HICKORY GROVE LAKE MECHANICAL DREDGING & SHORELINE ARMORING STORY COUNTY, IOWA PROJECT NUMBER: 16-02-85-05

November 6, 2018

This Addendum is issued to modify, explain or correct the original Drawings and Specifications, and is hereby made a part of the Contract Documents. Please attach this Addendum to the Project Manual in your possession. Insert the number and issue date of this Addendum in the blank space provided on the Proposal Form.

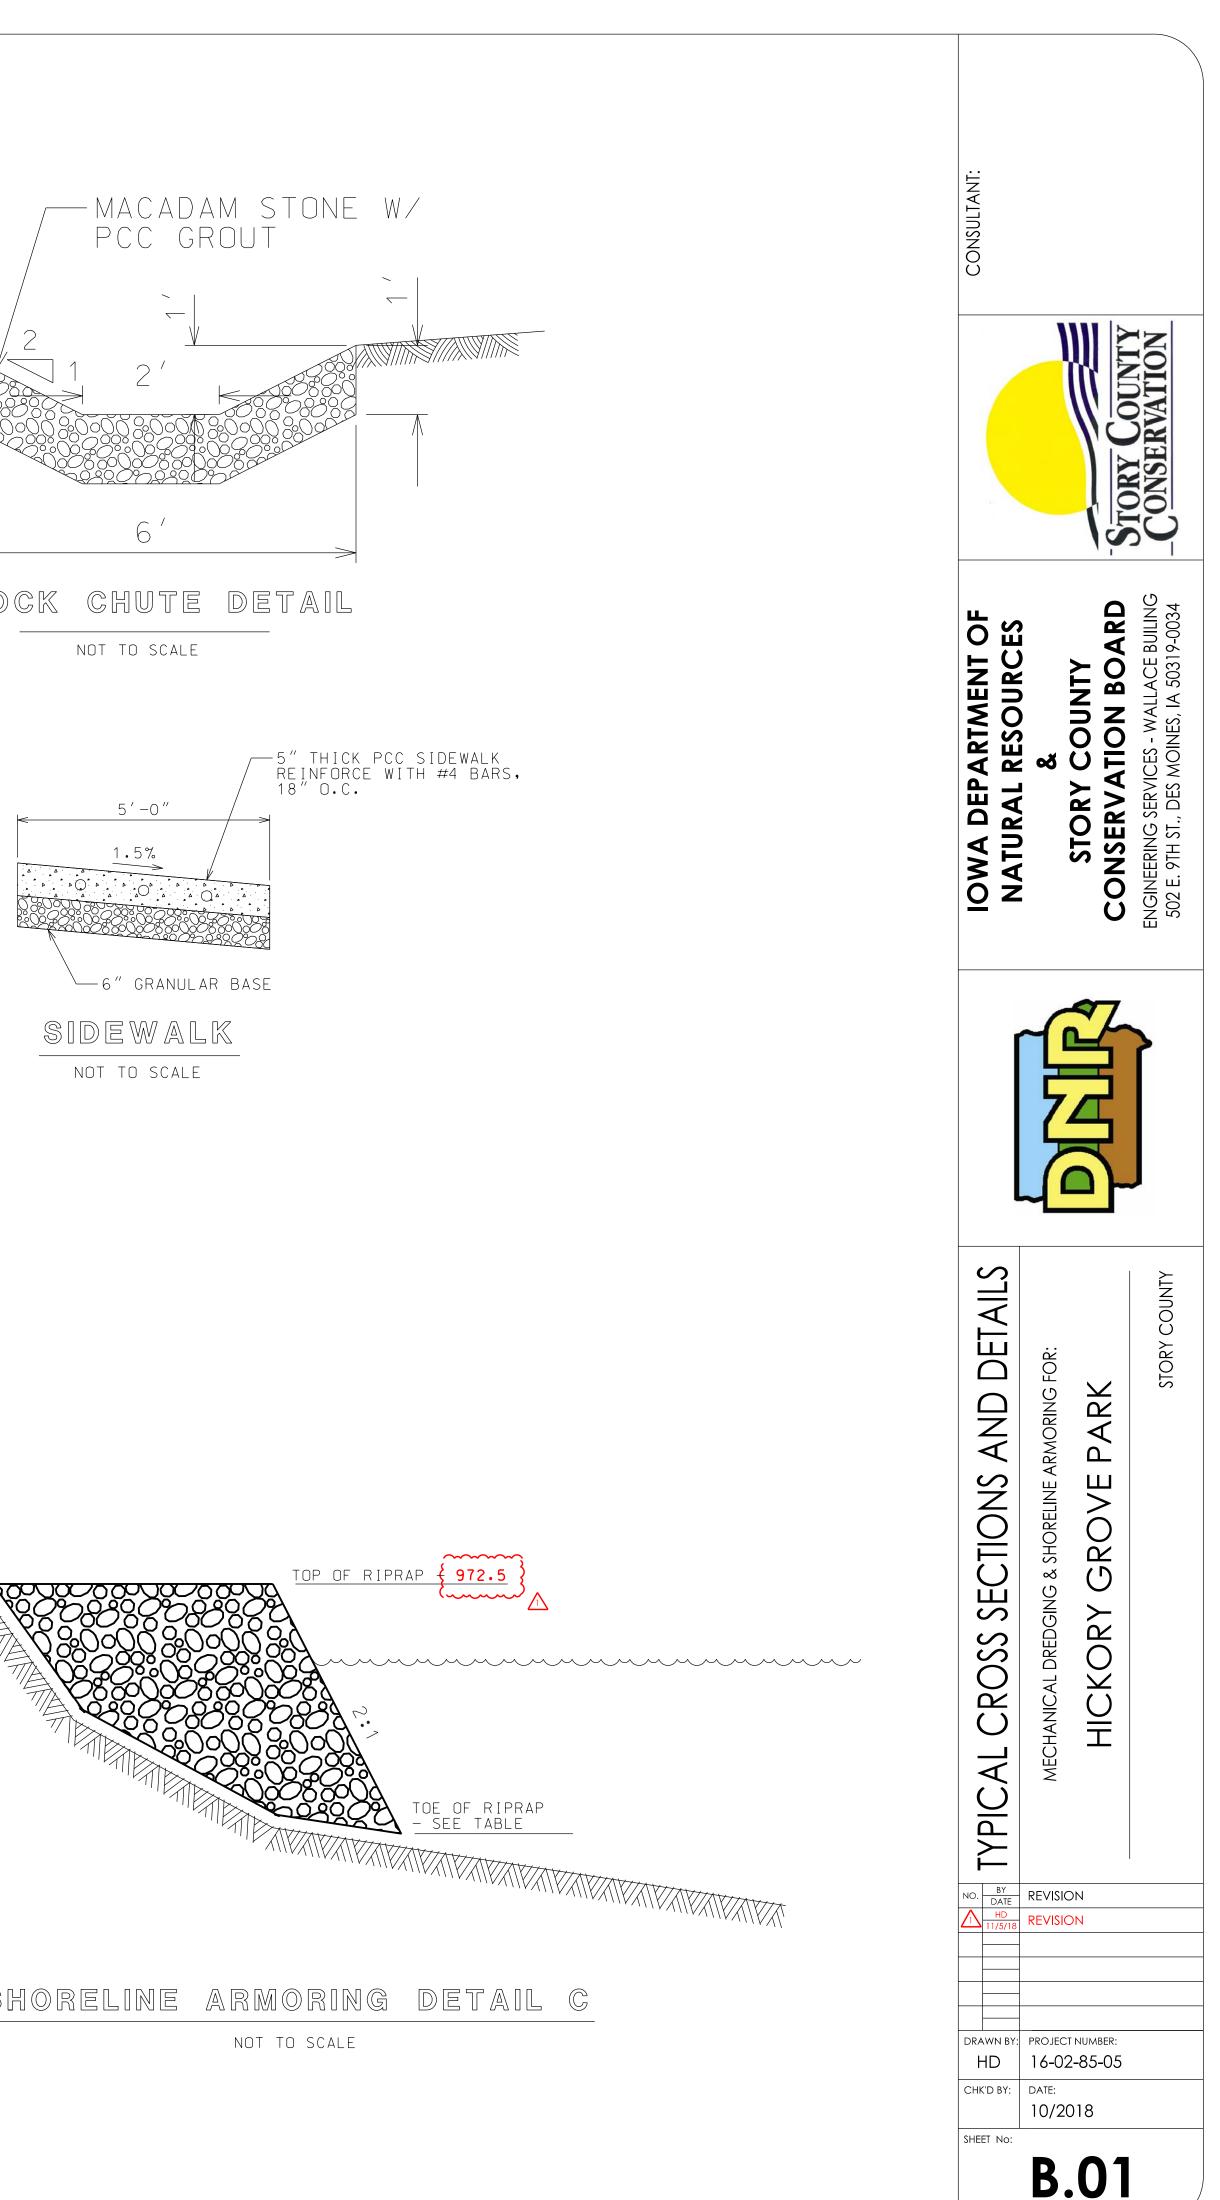
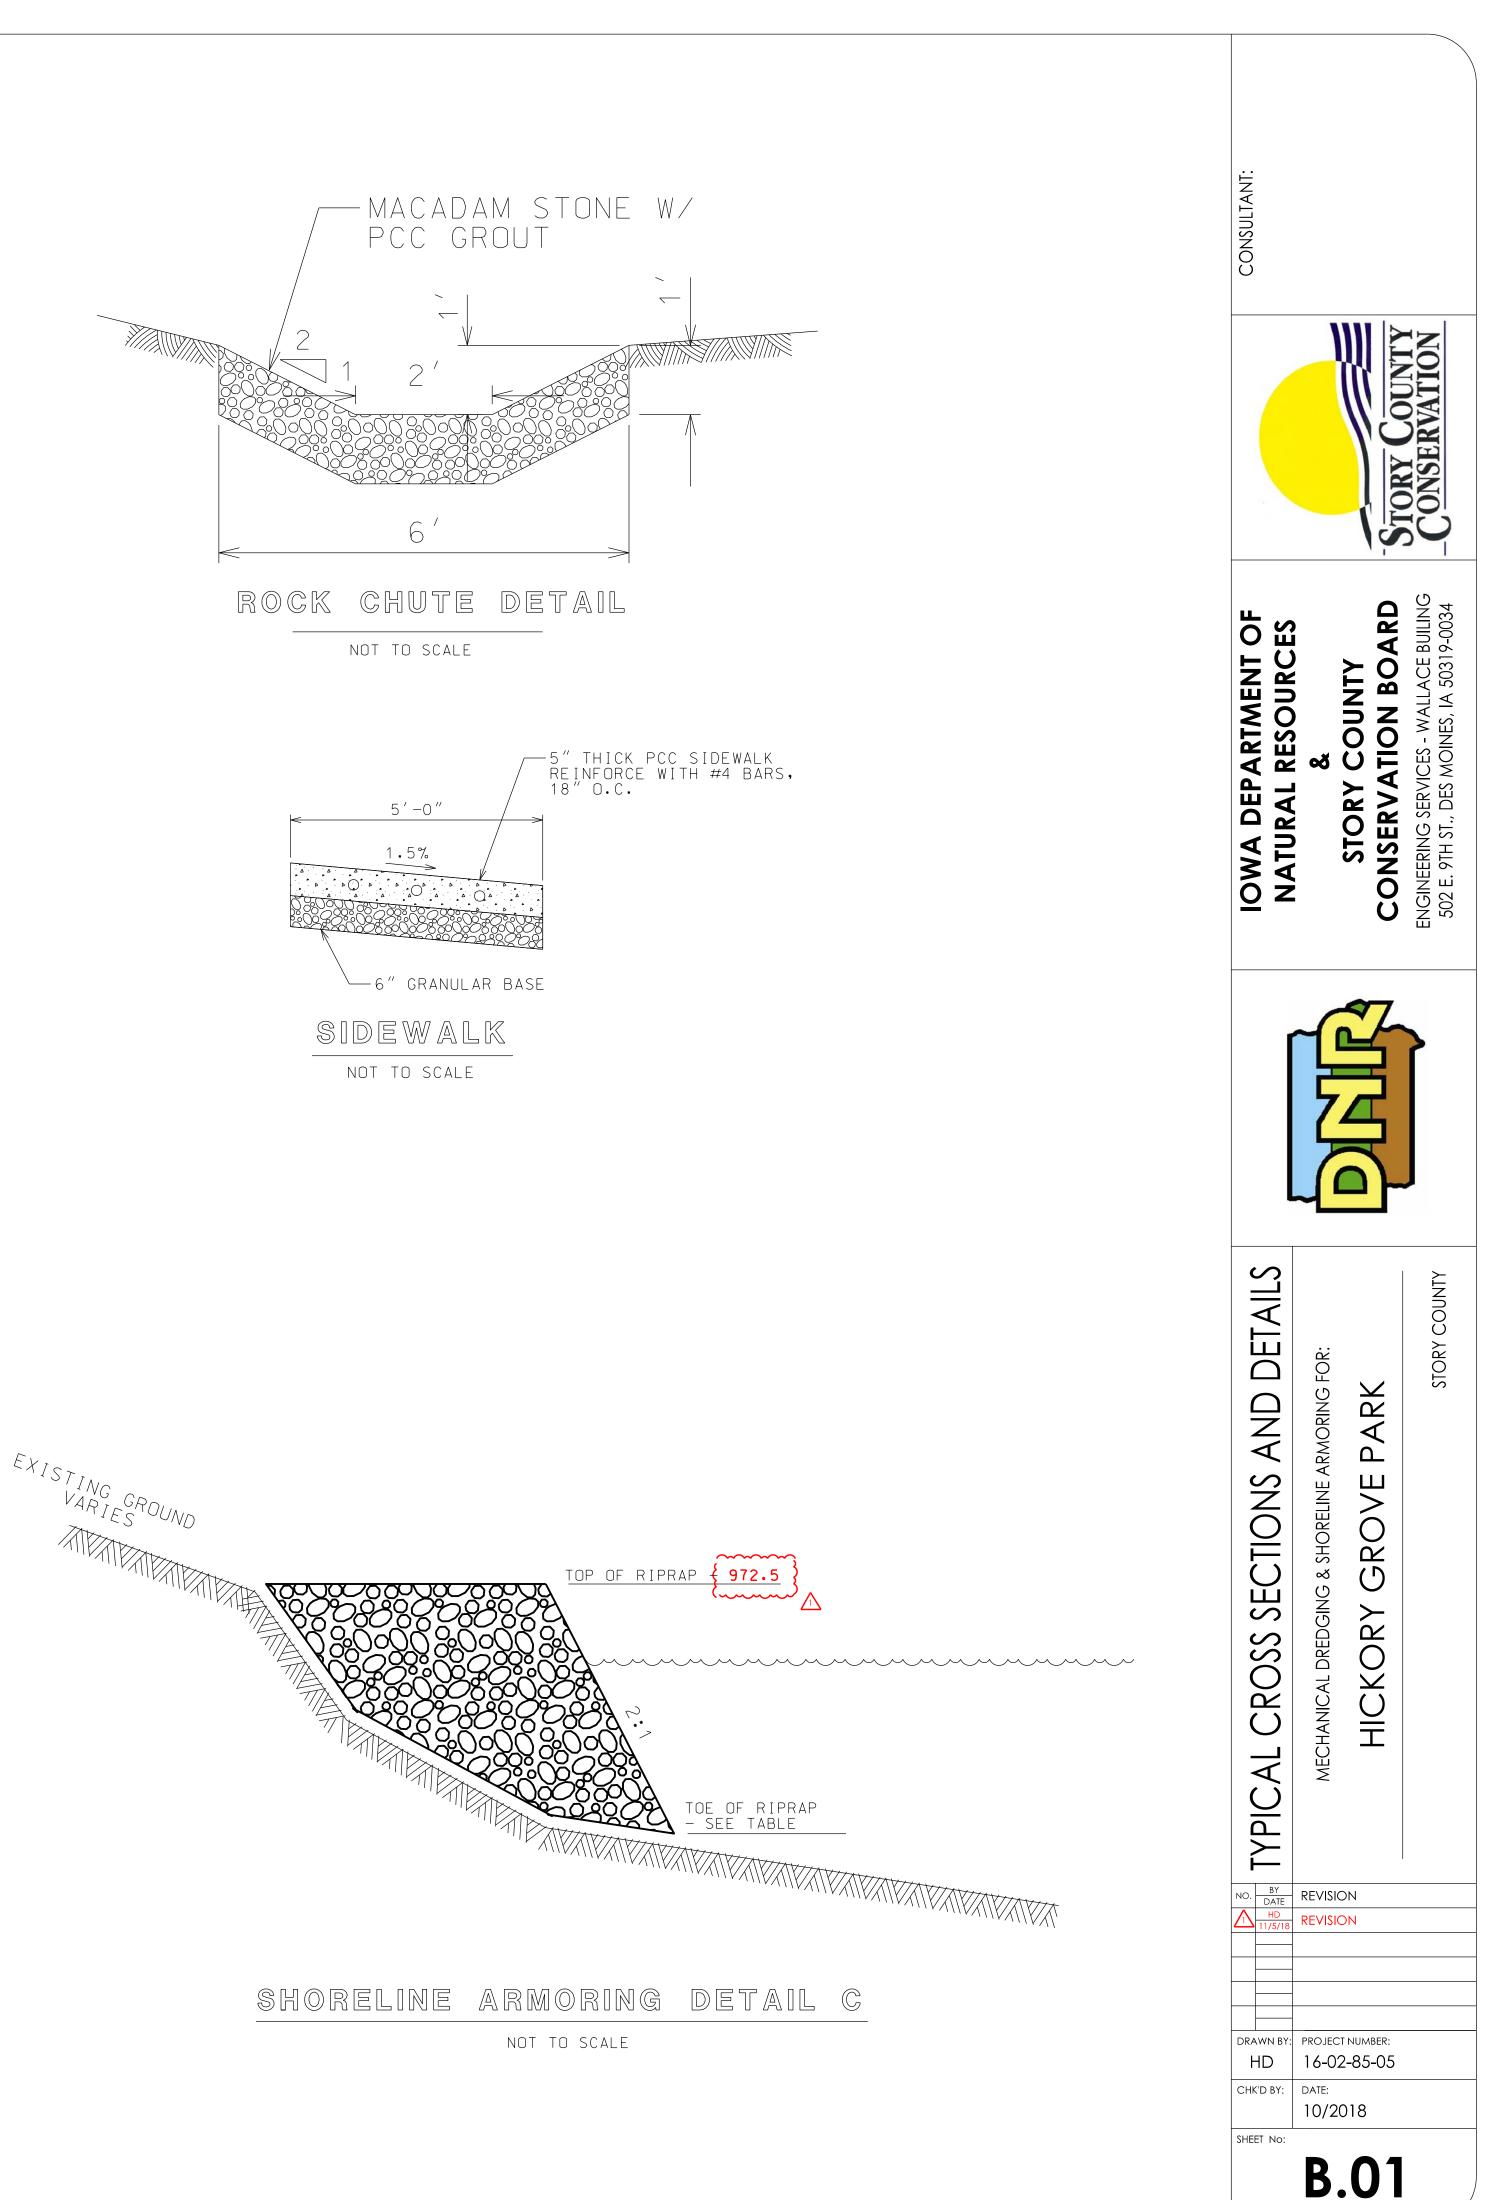
- A. B.01 The TOP OF RIPRAP elevation of the SHORELINE ARMORING DETAIL C is incorrect. Attached is the revised plan sheet.
 B. C.01 - The note for bid item #8.D is incorrect. Additionally, note F has
- been added to that bid item. Attached is the revised plan sheet.
- C. D.01 Dredge Area 5 was left off of the quantities table. Attached is the revised plan sheet.

ESTI	MAT	E REFERENCE INFORMATION
ITEN NO.	1	DESCRIPTION
1	A.	Payment for this bid item includes all material and labor to connect to an existing pipe, if necessary.
2	Α.	Material shall conform to gradation 21 and specification section 4125.
3	Α.	Payment for this bid item includes all material and labor to connect to an existing pipe, if necessary.
4	Α.	Payment for this bid item includes all material and labor to connect to an existing pipe, if necessary.
5	Α.	Control joints shall be incidental to this bid item and shall be spaced as directed by the DNR Engineer.
6		Control joint sawing, sealing, and center-steel is incidental to this bid item. Contractor shall submit joint plan to DNR Engineer for review and approval. Joint Plan shall conform to Iowa Department of Transportation standards. Joint construction shall follow the Iowa Department of Transportation Standard Road Plan PC-101. Joint spacing shall be approximately 12' O.C., and not exceeding 15'. The centerline joint along the driving lanes shall be centered in the lane, and shall be an "L" joint. Sidewalk cold joints shall meet detail "F". All other cold koints shall be a "KT" joint. 2' (min.) blockouts are required at acute angles.

7	A.	Payment for this bid item includes all material and labor to connect to an existing pipe.
8	B. C. D. E.	 Payment for this item consists of drawing the lake down to elevation 942 on a date determined by the contractor, within the window designated herein. The purpose of the draw down is to allow DNR fishery biologists the opportunity to manage rough fish. The contractor shall provide a two-week notice prior to the draw down. Continued dewatering pumping may resume no sooner than four weeks after 942 pool is achieved. This line item is for "2 each". The window for the first draw down is between ice-out of 2019 and 5/1/2019. The window for the second draw down is between 9/15/2019 and 11/30/2019. The initial draw down rate is limited to one foot per day, to prevent sloughing. Intake depth shall be no more than 5' below water surface. A trash screen shall be used on the inlet with openings no larger than 3". The lake shall not be pumped lower than 942.
